Work Order ID 65583

Item Name: Replacement Skidtube

DRAWING NO. D2580	TITLE 205 SKIDTUBE ASSEMBLY	REV. D	DART AEROSPACE LTD ENGINEERING ORDER		D.E.O. NO. D2580-D-1	SHEET NO. SHEET 1 OF 1	SCALE NTS
DRAWN <i>UP</i>	CHECKED <i>L</i>	MFG. APPR. <i>E</i>	APPROVED <i>MP</i>		DE APPR. <i>H</i>		
DATE 10.09.22	DATE 10.11.04	DATE 10.11.04	DATE 10/11/04		DATE 10.11.04

CHANGE ALL WELDED CROSSBOLT SPACERS TO SWAGED SPACERS

SECTION D-D & SECTION H-H ARE AMENDED AS FOLLOWS:

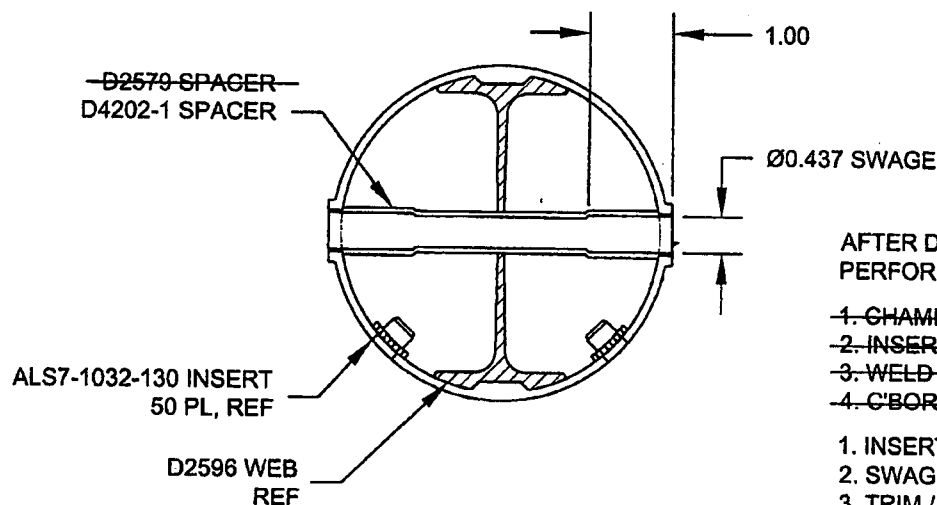
PARTS LIST IS AMENDED AS FOLLOWS:

WAS

QTY	QTY	PART NUMBER	DESCRIPTION
-041	-045		
20	24	D2579	CROSS BOLT SPACER

AFTER DRILLING AND BENDING ASSEMBLY
PERFORM THE FOLLOWING FOR Ø0.508 HOLES ONLY:

1. CHAMFER HOLE 0.050 X 45°
2. INSERT D2579 SPACER (20 PLACES)
3. WELD INTO PLACE AND GRIND FLUSH
4. C-BORE D2579 SPACER TO Ø0.437 X 1.00 DEEP

IS

20	24	D4202-1	SPACER
----	----	---------	--------

1. INSERT D4202-1 SPACER, 20 PL (-041) OR 24 PL (-045)
2. SWAGE TO Ø0.437 X 1.00 DEEP PER QSI 002
3. TRIM / GRIND FLUSH PER QSI 002
